Access Compliance Report

Public Rights-of-Way

Intersection ID: 9738	Main Street: CAMBRIDGE COMMONS DR	Cross Street: HORNWOOD CT	Location:	E
ADA ID: 19243334FD94	Ramp Type: Perp	Initial Pass/Fail: Fail	Overall Compliance: No	Severity Score: 60
Codes/Mitigation Info/Possible Solution		Field Measurements/Component Compliance

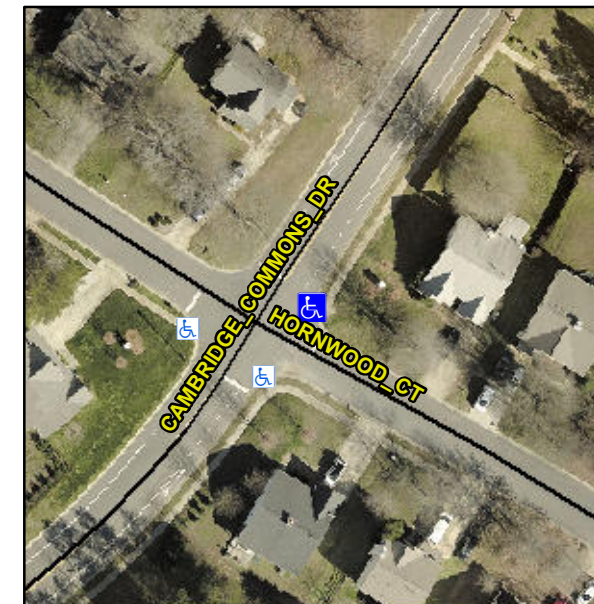
Not Found, R304.5.1, R304.5.3

Compliance	Description	Data	Compliance	Description	Data
N/A	Ramp Length (in)	96.0	Yes	Ramp Slope (%)	5.9
No	Ramp Width (in)	26.0	No	Ramp XSlope (%)	9.2
N/A	Flare Type LT	N/A	N/A	Flare Type RT	N/A
N/A	Flare Slope LT (%)	N/A	N/A	Flare Slope RT (%)	N/A
N/A	Flare Traversable LT?	N/A	N/A	Flare Traversable RT?	N/A
N/A	Landing Length (in)	N/A	N/A	DWS Provided?	N/A
N/A	Landing Width (in)	N/A	N/A	DWS Contrast?	N/A
N/A	Landing Slope (%)	N/A	N/A	DWS Length (in)	N/A
N/A	Landing X Slope (%)	N/A	N/A	DWS Full Width?	N/A
N/A	Landing Curb? (Y/N)	N/A	N/A	DWS Offset (in)	N/A
N/A	Shared Landing?	N/A			
N/A	Gutter Ponding?	N/A	N/A	Gutter Slope (%)	N/A
N/A	Gutter Lip Ht (in)	N/A	N/A	Gutter X Slope (%)	N/A
N/A	Painted X Walk1?	No	N/A	Painted X Walk2?	N/A
	X Walk 1 Direction	To SW		X Walk 2 Direction	N/A
N/A	X Walk 1 Width (in)	N/A	N/A	X Walk 2 Width (in)	N/A
	X Walk 1 Slope (%)	5.4		X Walk 2 Slope (%)	N/A
	X Walk 1 X Slope (%)	5.2		X Walk 2 X Slope (%)	N/A

Remove & Replace Entire Ramp.
